## HISTORIC AND DESIGN REVIEW COMMISSION

February 07, 2018

**HDRC CASE NO:** 2018-044  
**ADDRESS:** 170 HERMINE BLVD  
**LEGAL DESCRIPTION:** NCB 9007 BLK 13 LOT 5&6  
**ZONING:** R-4, H  
**CITY COUNCIL DIST.:** 1  
**DISTRICT:** Olmos Park Terrace Historic District  
**APPLICANT:** Joseph Gamez  
**OWNER:** Joseph Gamez  
**TYPE OF WORK:** Window replacement, concrete patio and driveway installation  
**APPLICATION RECEIVED:** January 22, 2018  
**60-DAY REVIEW:** March 21, 2018

170 HERMINE BLVD.  
SAN ANTONIO, TX 78212  
**PROPOSED CONCRETE DRIVEWAY**

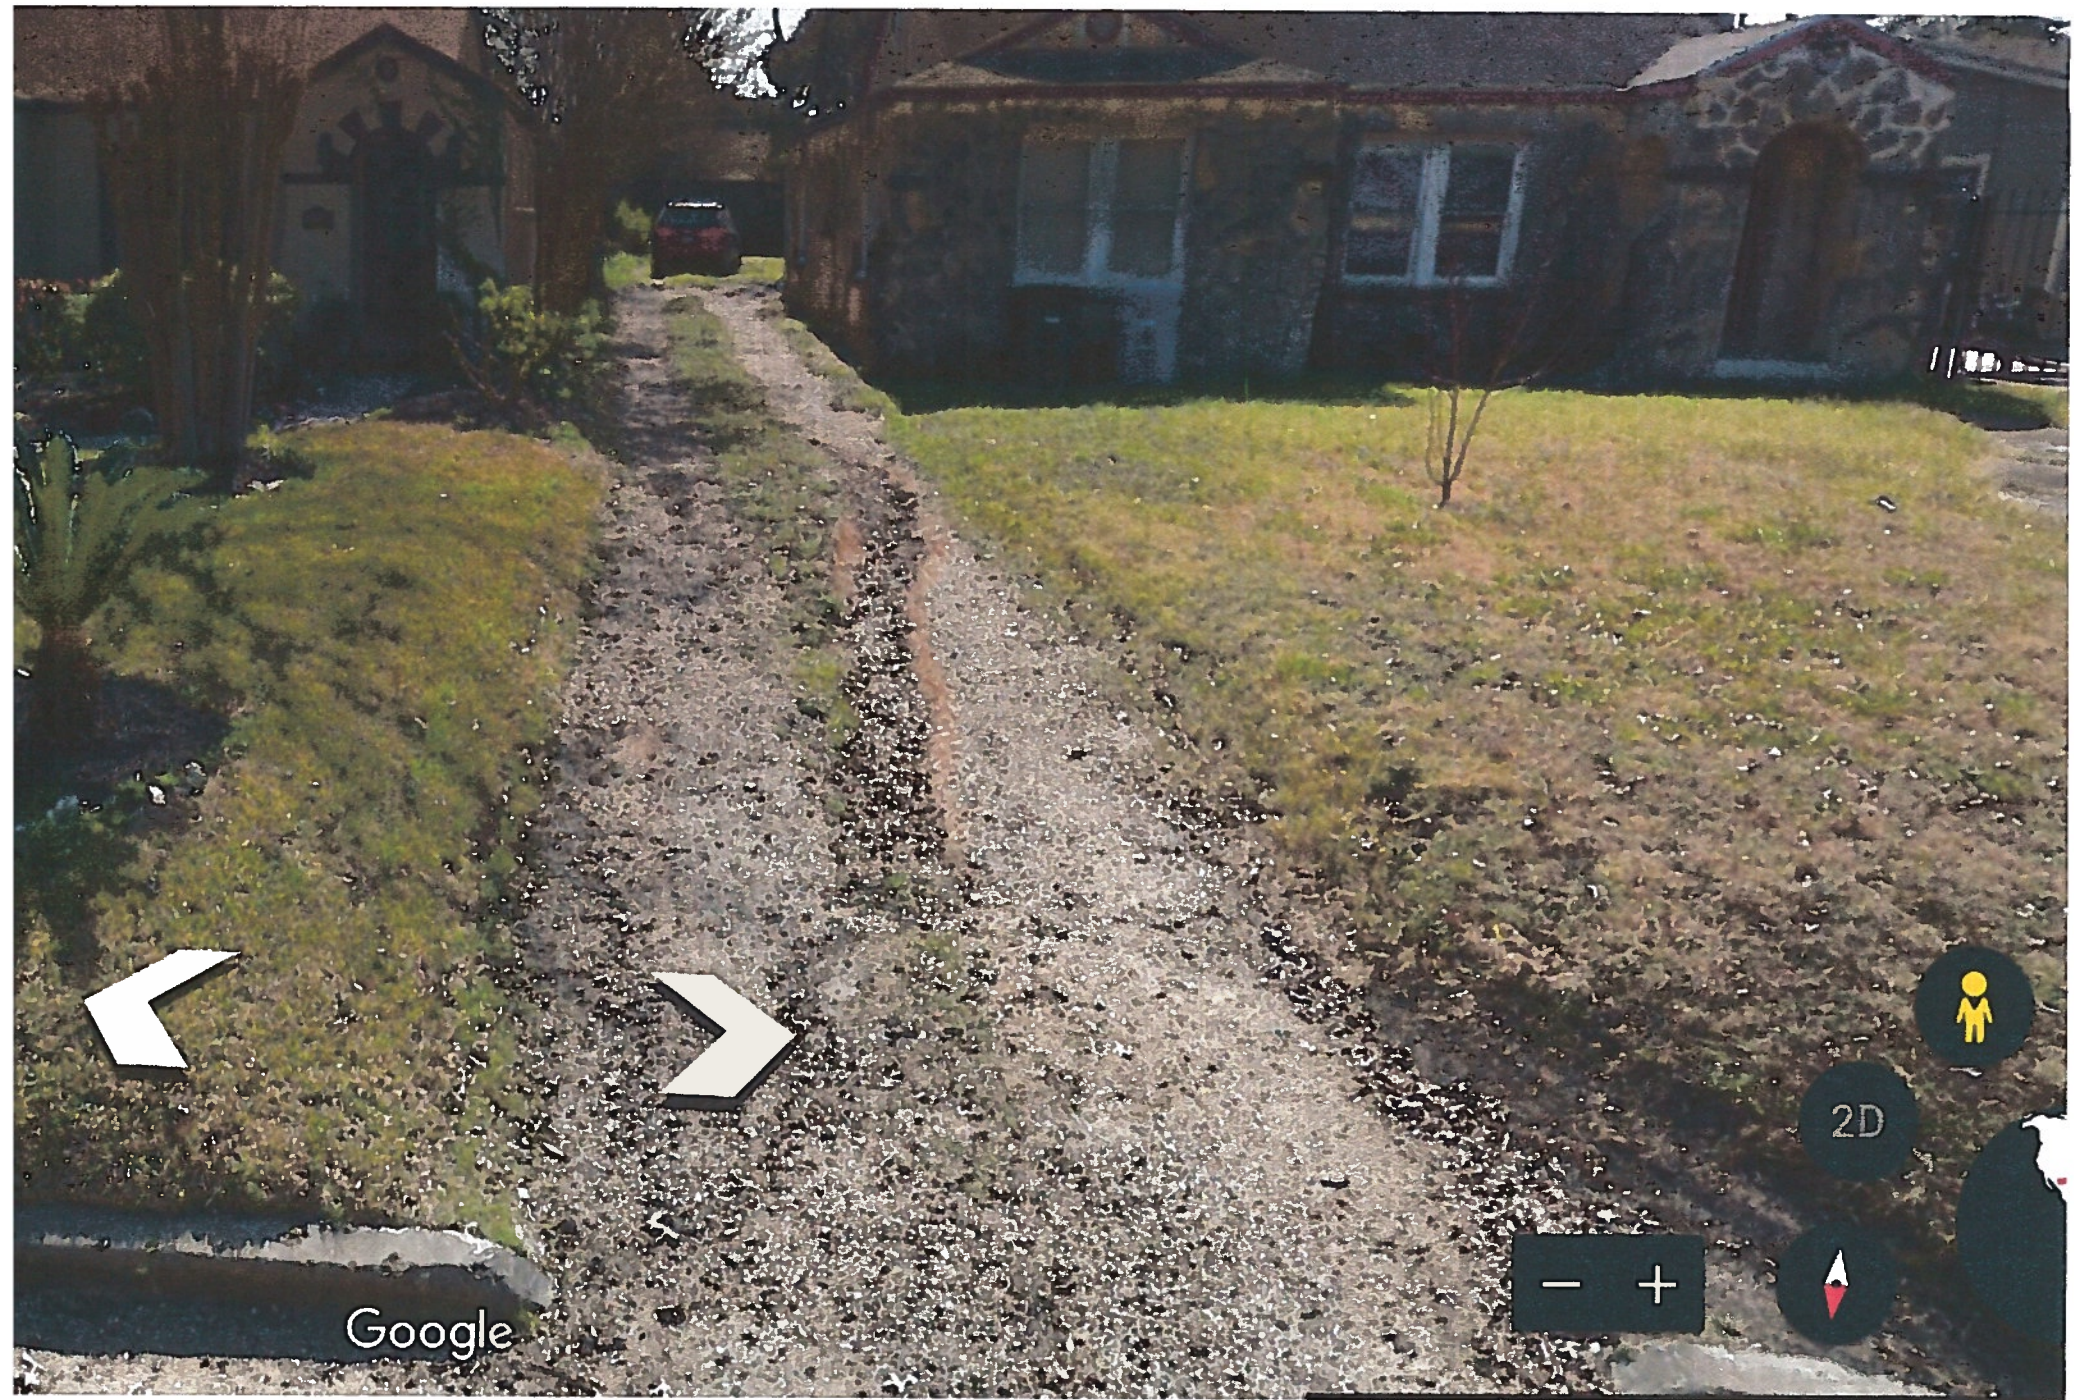
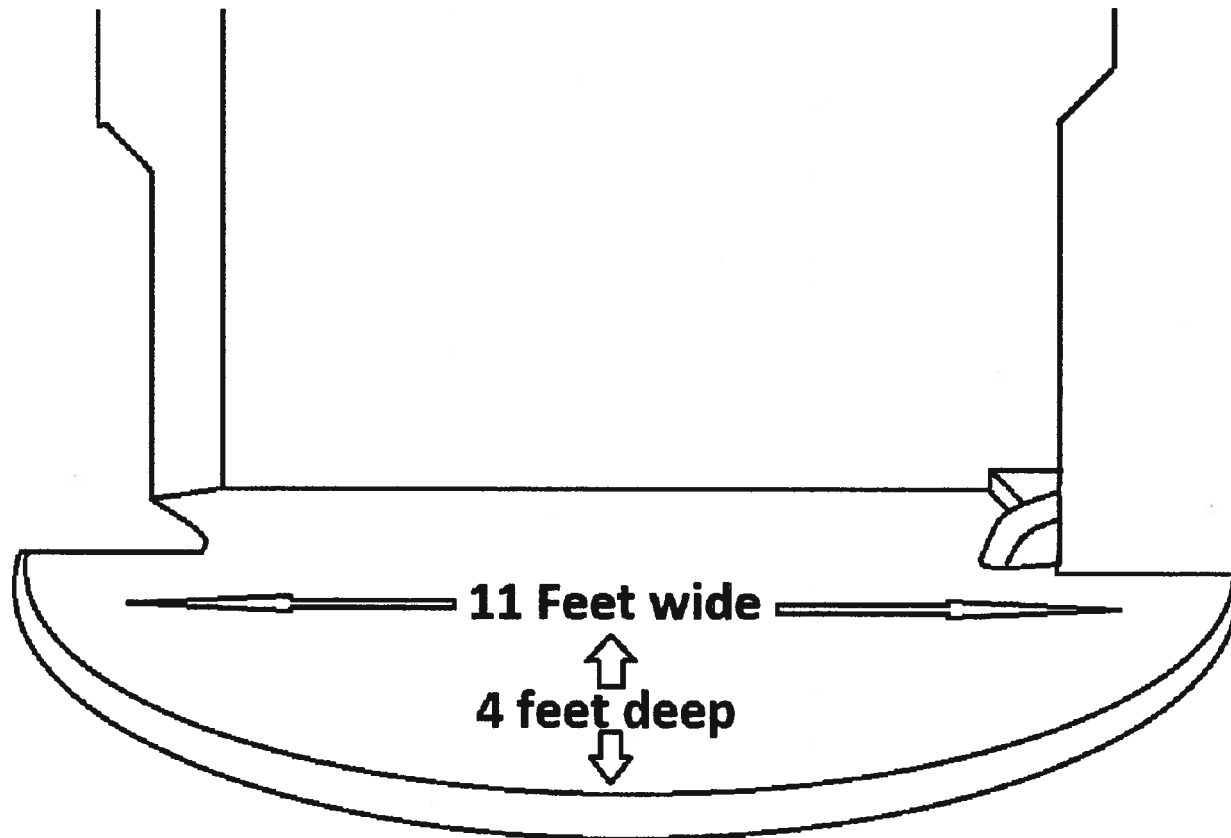
- e. **DRIVEWAY** – The applicant has proposed to install a concrete driveway to replace the existing, unpaved gravel driveway. The proposed driveway will feature 9 feet in width and 110 feet in length. Per the Guidelines for Site Elements 5.B.i, new driveway configurations should be similar in material, width, and design to that historically found on the site and that pervious paving surfaces may be considered where replacement is necessary. Given that the surrounding properties also include fully paved or concrete ribbon strip driveways, staff finds the proposed driveway appropriate.

2. Staff does not recommend the installation of the concrete patio based on finding d. Staff recommends the immediate removal of unapproved work.
3. Staff recommends approval of the concrete driveway as proposed based on finding e.
4. Staff does not recommend approval of the addition at this time based on finding f. The applicant can resubmit when the proper construction documents are provided.

170 HERMINE BLVD.  
SAN ANTONIO, TEXAS 78212  
**NEWLY INSTALLED PATIO**

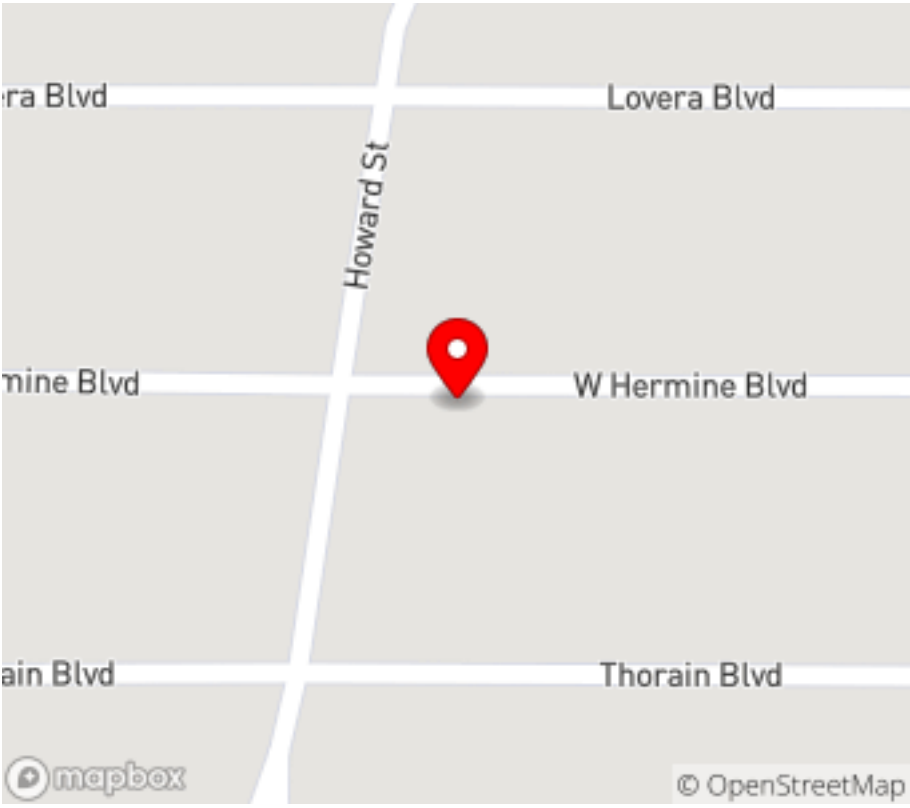
- d. **PATIO** – The applicant has partially installed a concrete rounded patio centered to the front façade.. Staff finds that there is no evidence of an existing patio in this location or configuration associated with this structure or its architectural style. Staff does not find the patio consistent with the Guidelines for Site Elements 7.B.
